THM 440-T4 INPUT CLUTCH ACCUMULATOR ELIMINATED

Figure 1
AUTOMATIC TRANSMISSION SERVICE GROUP

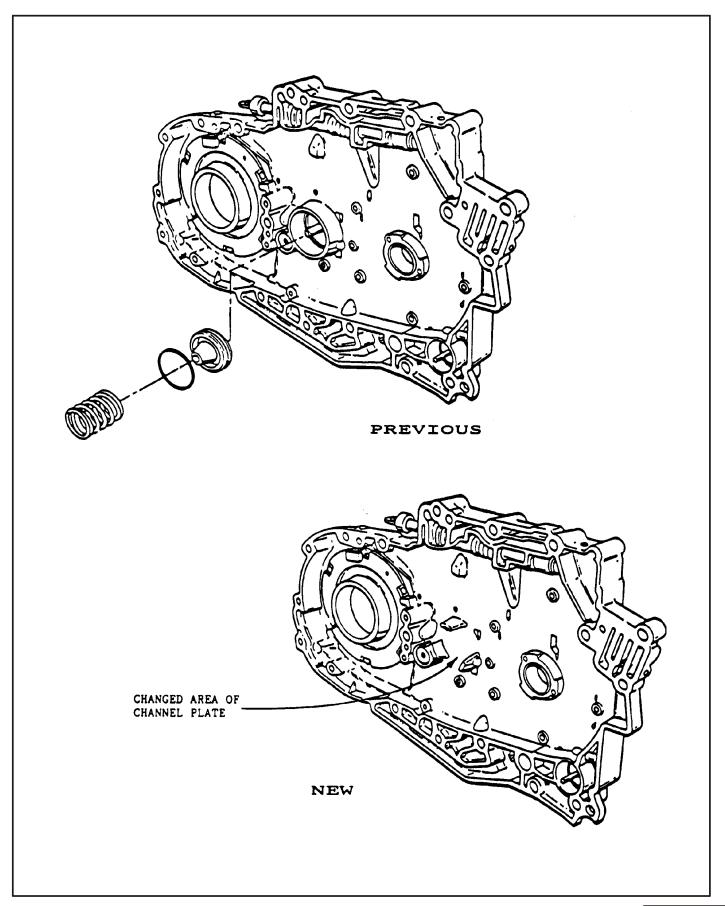
CHANGE: The Input Clutch Accumulator has been eliminated from the channel plate (See Figure

1).

PARTS AFFECTED: (1) CHANNEL PLATE - The input clutch accumulator piston, piston pin, and

accumulator spring have been eliminated from the channel plate, which also changes

the casting (See Figure 1).

Figure 2
AUTOMATIC TRANSMISSION SERVICE GROUP

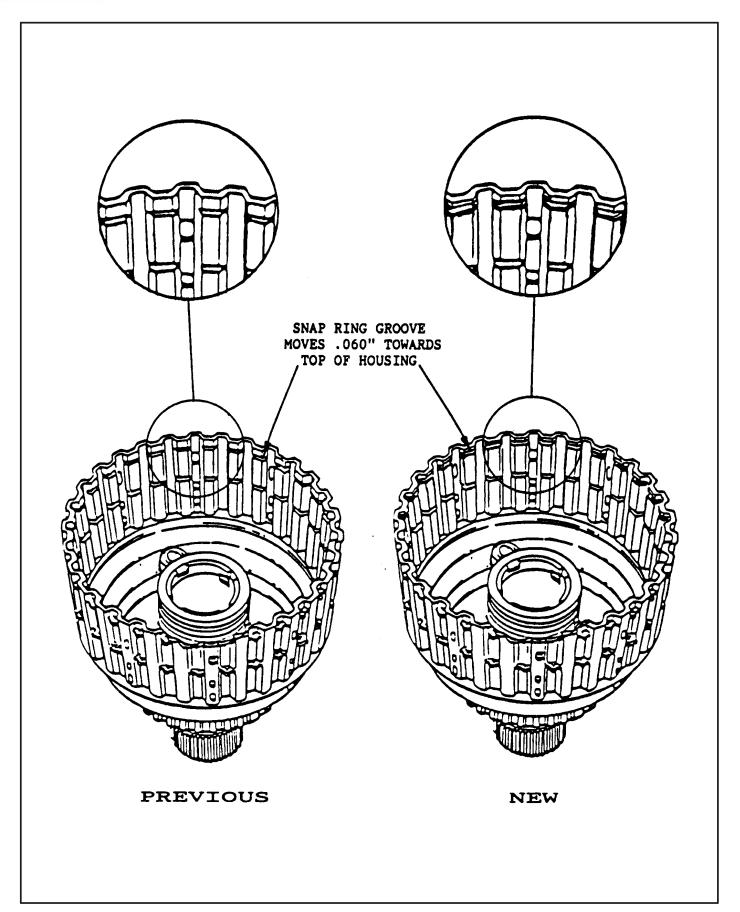
(2) **INPUT HOUSING** - Top snap ring groove moves ,060" closer to the top of the

input housing, to 1 ccommodate the added wave plate (See Figure 2).

Figure 3

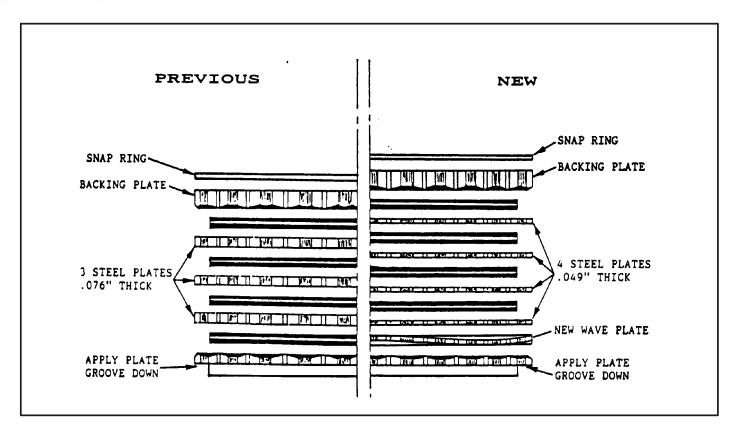
(3) INPUT CLUTCH STEEL PLATES - The steel plates are ,027" thinner to 1

ccommodate the added wave plate (See Figure 3). The new steel plates are,049" thick, and the old steel plates are ,076" thick.

(4) INPUT CLUTCH "STACK" - The input clutch stack has been revised to accommodate the new changes. Refer to Figure 3 for proper assembly of the new input

clutches.
